Santa Cruz County Advisory Panel on the South32 Hermosa Project Tin Shed Theatre, 304 Naugle Avenue, Patagonia, AZ

Meeting Minutes for November 15, 2023
Santa Cruz County Advisory Panel on the South 32 Hermosa Project
The Tin Shed Theater, 309 McKown Avenue, Patagonia, AZ

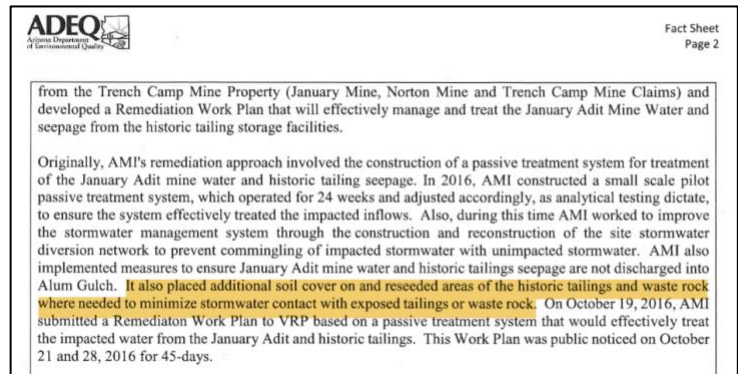
ADEQ states that these restrictions are to ensure “that no new sources will be discharged to an impaired water as required by the *San Carlos* decision.” (Draft Fact Sheet at 6).²⁷

²⁷ Inexplicably, ADEQ also states: “If 100% reuse is not possible, effluent from WTP1 may be discharged from Outfall 001 to Upper Alum Gulch...” Draft Fact Sheet at 3. Presumably this means that drainage from non-historic sources may be discharged from Outfall 001

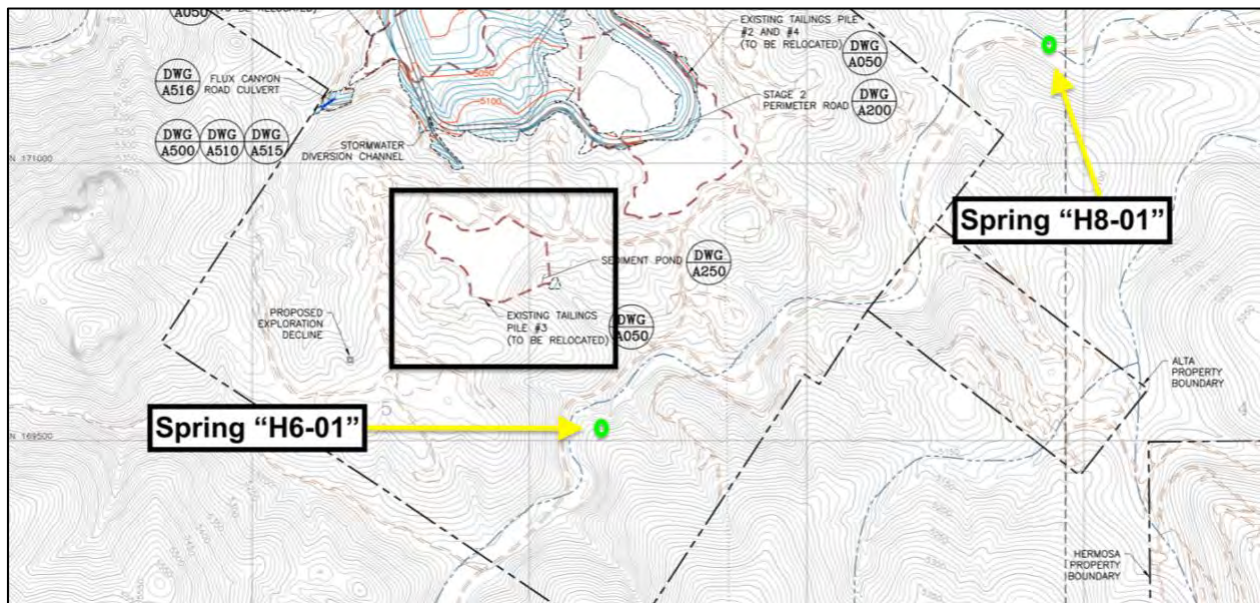
own description in the 2003 TMDL. See below (excerpt of Figure 3 from Arizona Minerals, Inc.'s Aquifer Protection Permit Application, Trench Camp Property dated June 5, 2017).
